## UNITED STATES DEPARTMENT OF COMMERCE National Oceanic and Atmospheric Administration

2010/01235:RAB

MEMORANDUM FOR: Mosler Rock-Ojai Quarry Recommendations

**SUBJECT:** Effects of Mining Activities on Endangered Steelhead in the North

**Figure 11**. Zoom view of the south sediment detention basin. Note high sediment load in basin that accumulated after April 12, 2010, 1.76" rain event. Photo taken April 15, 2010, by NMFS.

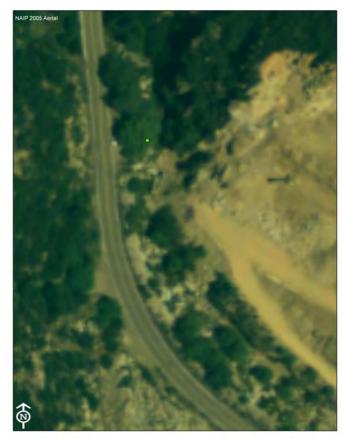
was installed as a measure to prevent Quarry sediment that washes off bare slopes and quarry roads during rain events from entering the North Fork. Based on NMFS' site visit observations, the frequency that the fine sediment is removed from the basin is not clear. Due to the 1) small size of this basin, 2) lack of drainage features, 3) large amount of loose upslope Quarry material, and 4) close proximity to the adjacent unstable landslide slope, it is reasonable to expect that this basin can fill, frequently, with Quarry material and be rendered ineffective, and the narrow earthen dam on the unstable slope face can fail and cause another landslide at this site (Figure 10). In response to NMFS' questions regarding the frequency that sediment needs to be removed from the south sediment detention basin, the quarry operator stated that the fines need to be removed from that basin on a regular basis. At the time of NMFS' April 15, 2010, site visit, the south sedimentdetention basin had accumulated a high level of fine sediment in response to a moderate 1.76-inch rain event on April 12, 2010 (Matilija Dam Station #304). It does not appear that the south sediment basin, as constructed, can effectively capture and retain a sufficient amount of the quarry sediment runoff, particularly during moderate to large storm events (Figure 11). Furthermore, the basin spillway does not appear to function effectively. Evidence suggests that water-sediment slurry flows freely from the basin to the creek during storm events as suggested by the swath of unvegetated gravel and fine sediment that is visible leading away from the basin spillway to an erosion channel beneath the SR-33 bridge (Figure 11). Aerial photographs of the Ouarry property demonstrate the loss of vegetative land cover and the extensive areas of exposed soil that are burdening the two small sediment detention basins during storm runoff (Figures 12 & 13).

We recommend that the Quarry implement a revegetation plan to NMFS and CDFG in order to rehabilitate the barren landscape and redesign both sediment basins to adequately capture all Quarry property sediment runoff. NMFS believes a crucial step in the control of sediment runoff from the Quarry will rely on the Quarry developing a sediment-maintenance plan that mandates removal of the sediment from both detention basins after each rain event to maintain adequate sediment-capture capacity, as well as requires proper storage of the collected sediment that is removed from the detention basins. In its current configuration, the Quarry does not have an adequate fine sediment storage containment area that prevents sequestered sediment from making its way back into the sediment-detention basin slurry and potentially entering the North Fork (Figure 14). NMFS recommends that the Quarry seek outside assistance from experts in the field of stormwater management (i.e., RWQCB) to redesign the sediment detention basins in order to minimize sedimentation concerns from the Quarry property. The California Stormwater BMP Handbook (2003) provides guidance on recommended designs for this type of sediment detention structures.
